Service Bulletin

Bulletin No.: 21-NA-148

Subject: Diagnostic Aid – DTC P2797, P2798 or P0C2D for Transmission Fluid Pump Performance

Brand:	Model:	Model Year:		VIN:		Engine:	Transmission:
		from	to	from	to		
Chevrolet	Bolt EV	2021	2023	—	—	EN0	1ET25 Automatic (MMF)
	Bolt EUV	2022

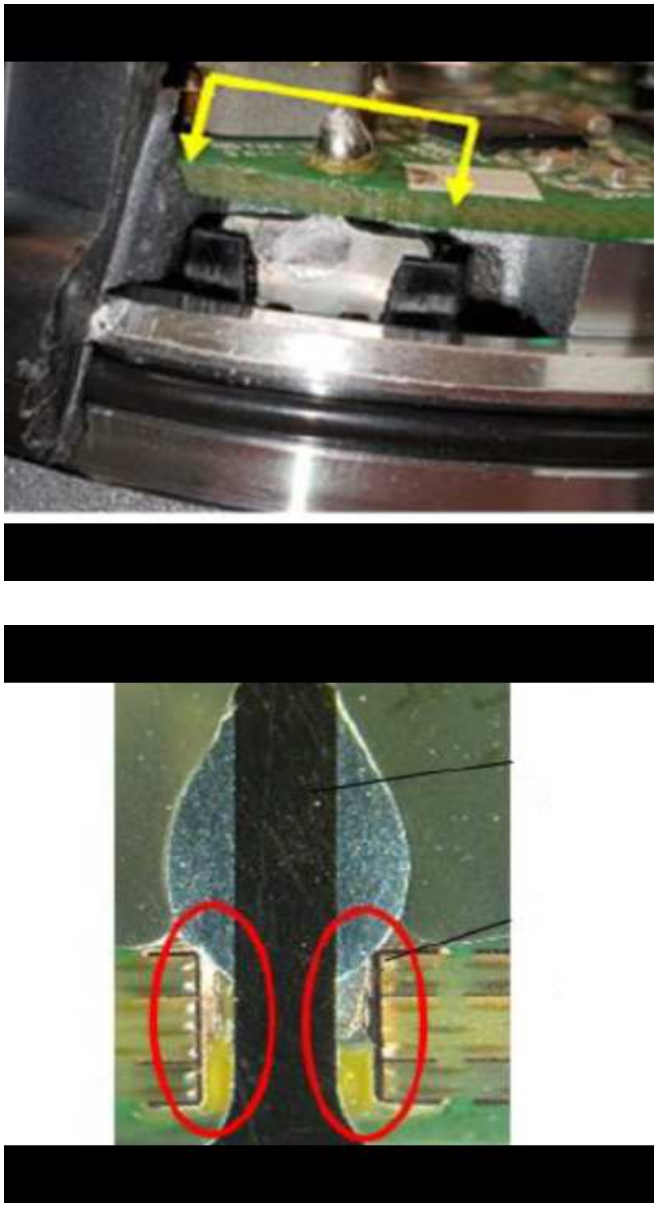
<p>Cause</p>	 <p>5867264</p> <p>5867265</p> <p>A part quality spill has been identified with the low voltage electric transmission fluid pump attached to the driver side of the transmission. A soldering process was out of specification like the illustration above.</p> <p>Note: The pump motor is not internally serviceable and the pictures provided are only for helping to visually show the issue.</p>
<p>Correction</p>	<p>Replace the transmission fluid pump.</p> <p>Important: The pump motor is not internally serviceable.</p>

If you encounter a vehicle with the above concern, replace the transmission fluid pump. Refer to *Transmission Fluid Pump Replacement* in SI.
